**DECLARATION OF TERRY
TOWNSEND IN SUPPORT OF
DEFENDANT RUBY HILL
OWNERS' ASSOCIATION'S
OPPOSITION TO PLAINTIFFS'
MOTION FOR PRELIMINARY
INJUNCTION**

**Reddy Residence
3737 W. Ruby Hill Drive**

**Side-by-side Comparison of
Approved Plans and As-built
Condition**

FRONT ENTRY DOORS

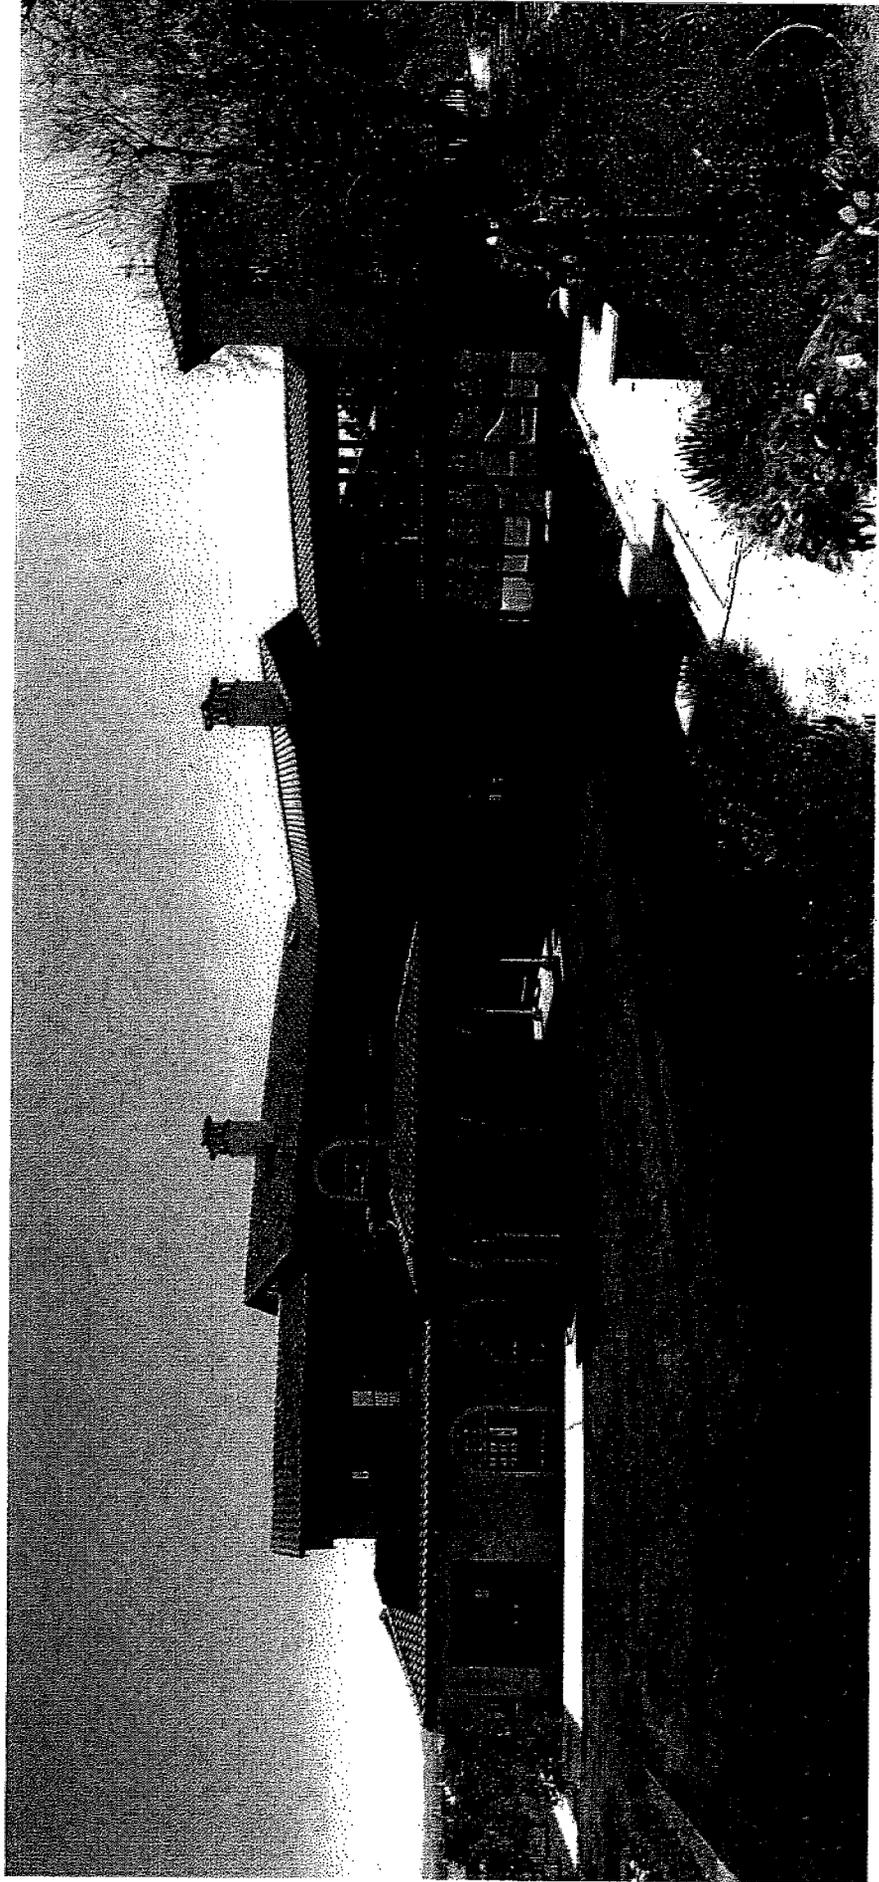
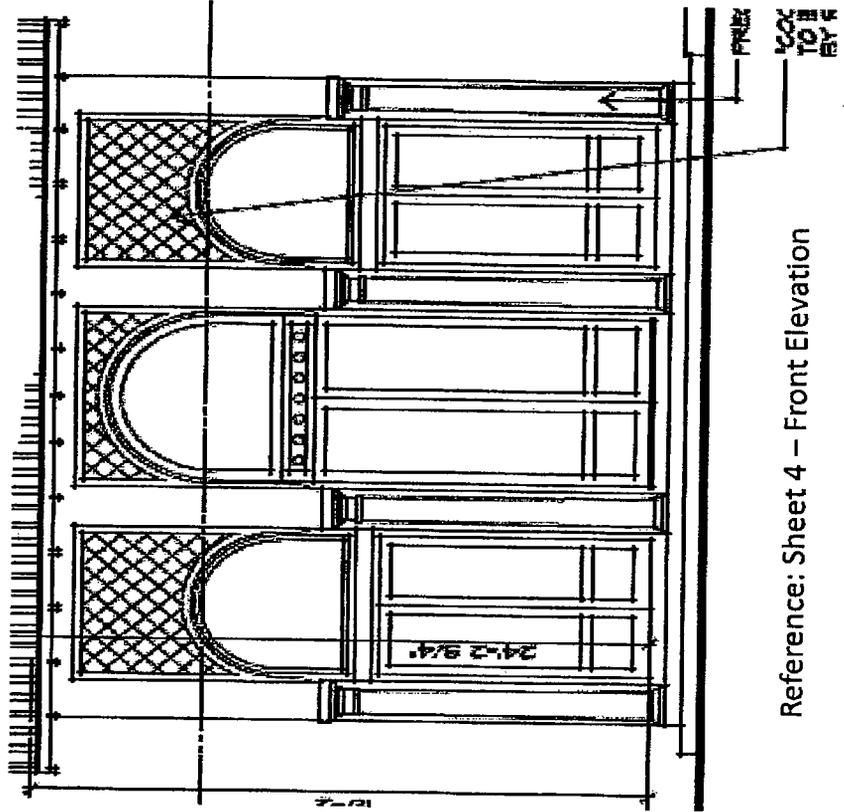
9 38. **Front Entry Doors (Item #13)**. Exhibit F, pages 11-12, are entitled “Front Entry
10 Doors”. The June 30, 2010 approved plans in the Final Design depicted entry doors with wood
11 panel doors without glass or iron work and simple arched transom windows above. The as-built
12 condition has an iron frame with glass inserts and overly ornate ironwork with gold accent for both
13 the door and transom above. Page 12 shows additional examples of the Reddys’ architectural
14 noncompliance for the center and side doors. The allegations in Paragraph 26 (3) of the Reddy
15 Complaint at p. 9:11-18 are untrue. The ADC never received a formal submittal of the proposed
16 doors prior to installation and the doors would not have received ADC approval of this deviation
17 from their prior approved plans. The doors on the drawing as depicted on Exhibit F, pages 11 and
18 12, are solid wood and without any iron work. A photo from the Hubbard Iron Doors in the catalog

Front entry doors depicted on final approved drawings (6.30.10)

- Wood panel doors without glass or iron work
- Simple Arched transom windows above

- As-built condition:
- Iron frame w/glass inserts
 - Overly ornate ironwork with gold accent for both door and transom above

FRONT ENTRY DOORS

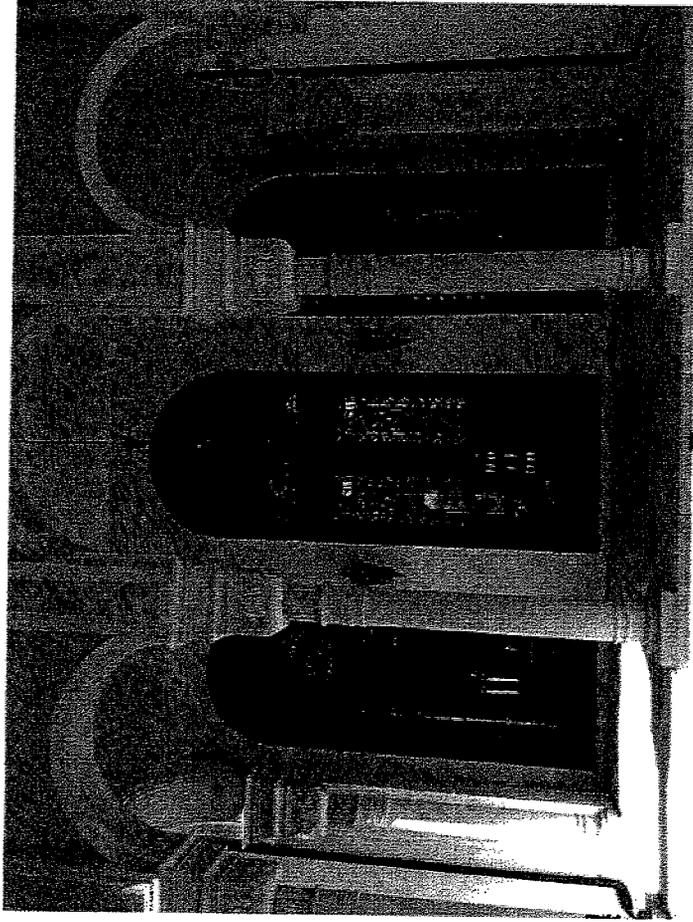
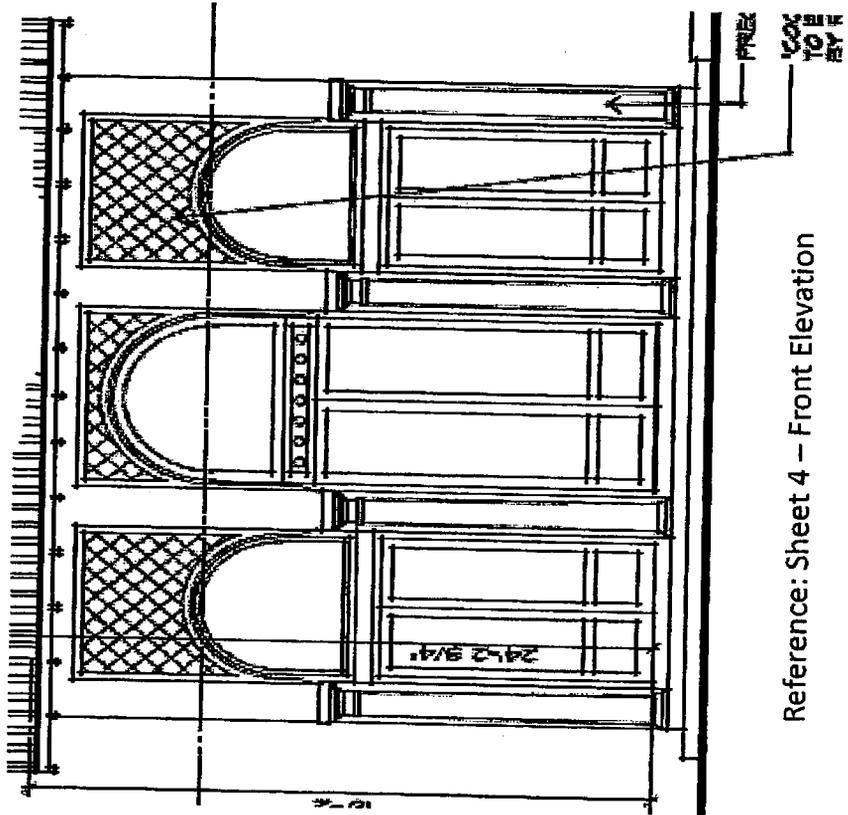
Front entry doors depicted on final approved drawings (6.30.10)

- Wood panel doors without glass or iron work
- Simple Arched transom windows above

As-built condition:

- Iron frame w/ glass inserts
- Overly ornate ironwork with gold accent for both door and transom above

HORIZONTAL BAND AT FRONT ELEVATION

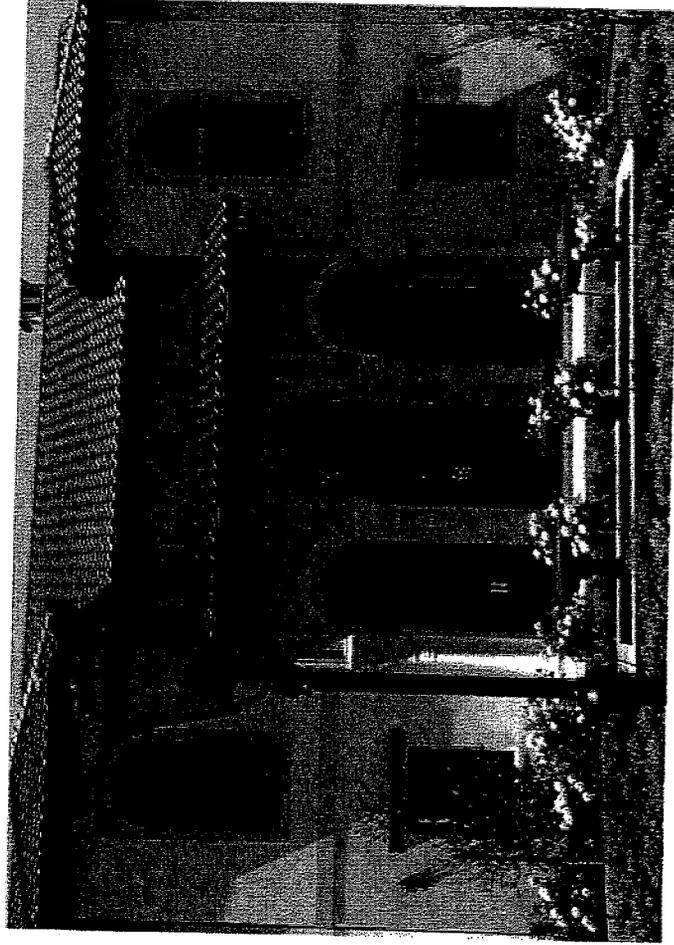
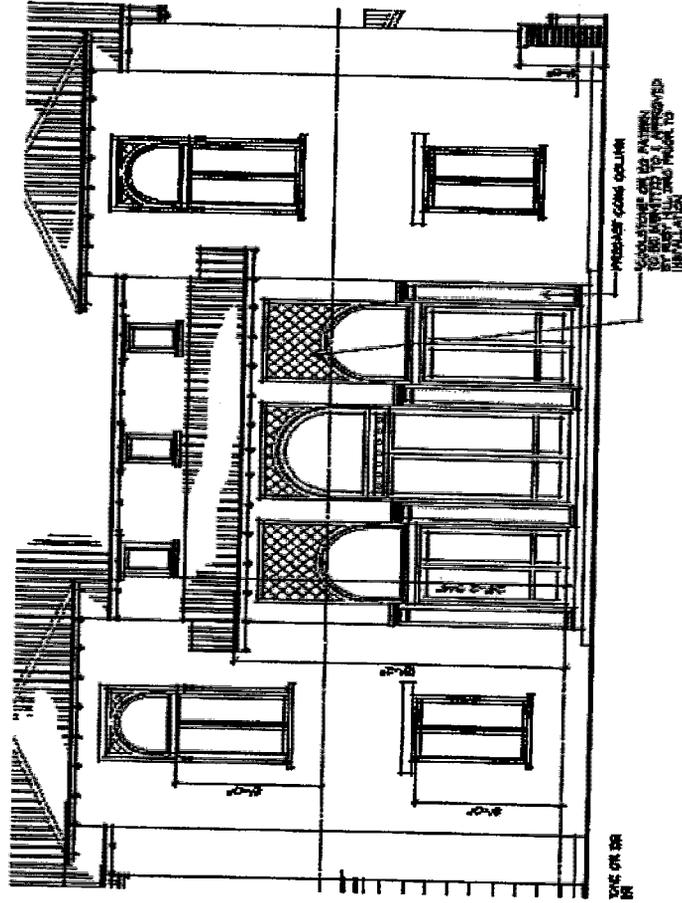
15 40. Horizontal Band At Front Elevation (Item #16). Exhibit F, p. 15, is entitled
16 "Horizontal Band At Front Elevation." This as-built condition is another example where the Reddys
17 added architectural elements that were not submitted to the ADC for prior approval before
18 construction, nor was included in the Final Design approved on June 30, 2010 by the ADC. The
19 approved plan on the left hand side of the page depicts the front elevation void of any horizontal
20 trim work. Notwithstanding this nonconformity with the approved plans and the Reddys' failure to
21 obtain prior written approval before construction, the ADC would approve this added trim work if it
22 were painted to match the approved body color. The ADC's willingness to accommodate the
23 Reddys is further evidence that the ADC did not act either arbitrarily or capriciously, but instead
24 acted reasonably.

Front elevation depicted on final approved drawings (6.30.10). Void of any horizontal trim work

As-built condition. Horizontal banding added without approval. ADC will accept the added trim work under the condition that it is painted to match the approved body color.

PRECAST COLUMNS

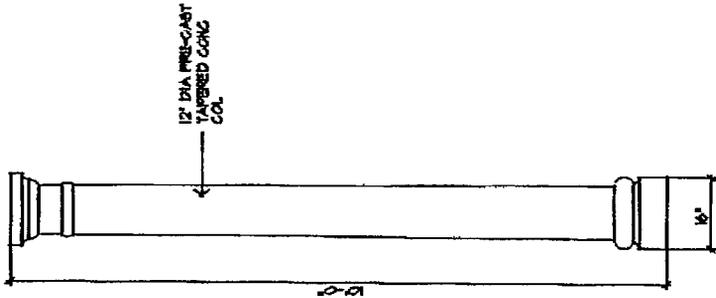
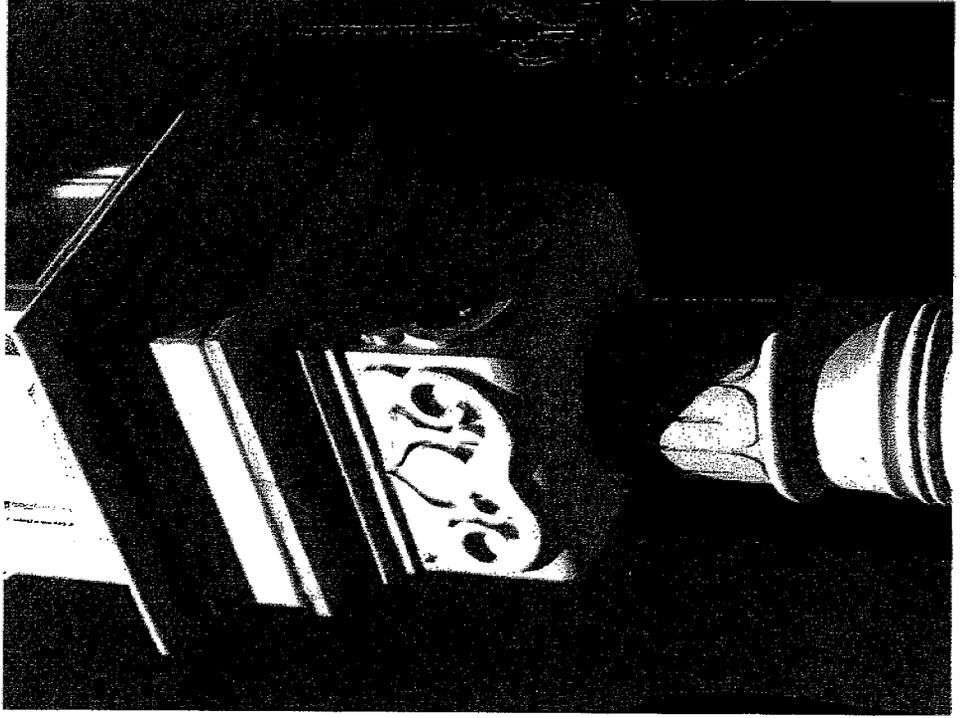
As-built condition. Design is inconsistent with the Spanish Eclectic architectural style.

Column elevation depicted on final approved drawings (6.30.10). Simple Tuscan capital

REAR GARAGE DOORS

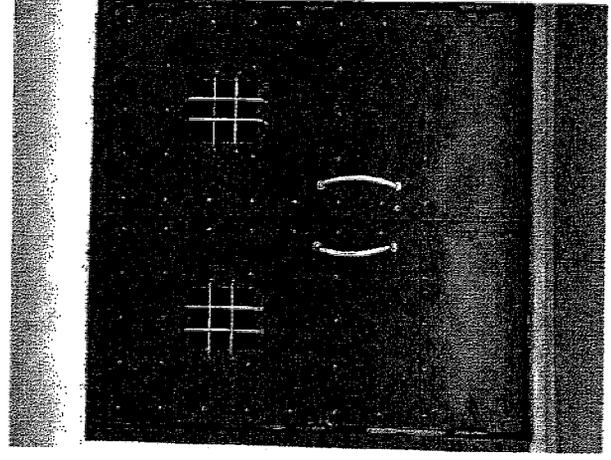
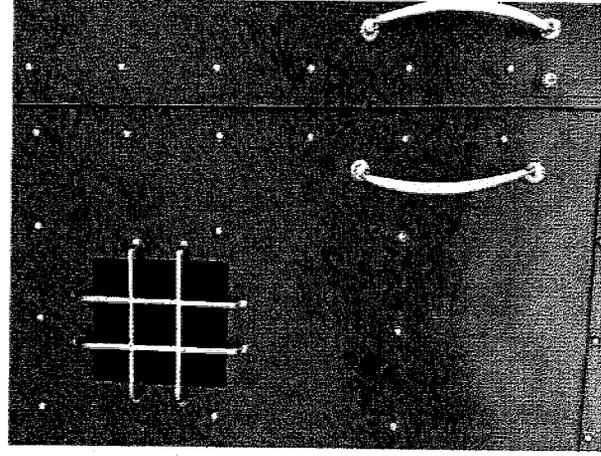
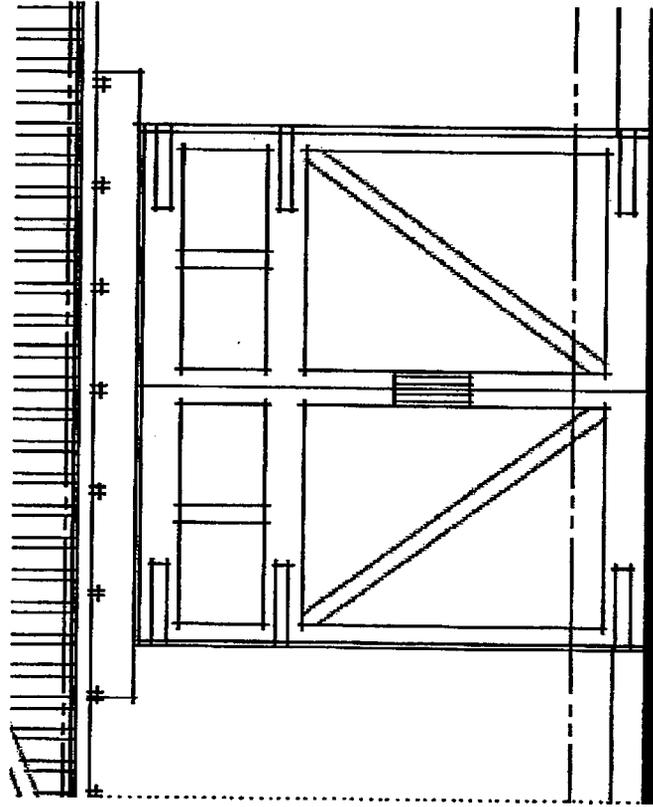
18 43. Rear Garage Doors (Item #34) Exhibit F, p. 18, is entitled "Rear Garage Doors".
19 The rear garage door on the Final Design matches the wood garage doors at front. The as-built
20 condition was constructed without the prior written approval of the ADC as it deviated from the
21 approved plans and the ADC would not have approved this change in the plans. The as-built
22 condition is not approved as they consist of iron doors with gold accent and openings with iron bars.
23 This iron work and gold accenting is too industrial. The as-built condition does not match
24 Monterey/Spanish Eclectic architectural style. The ADC did not act either arbitrarily or
25 capriciously, but instead acted reasonably.

Rear garage door depicted on final approved drawings (6.30.10). Matches wood garage doors at front.

- Iron doors with gold accent and opening with iron bars
- Iron work and gold accenting is too industrial and would not be approved if submitted.
- Does not match Spanish Eclectic architectural style
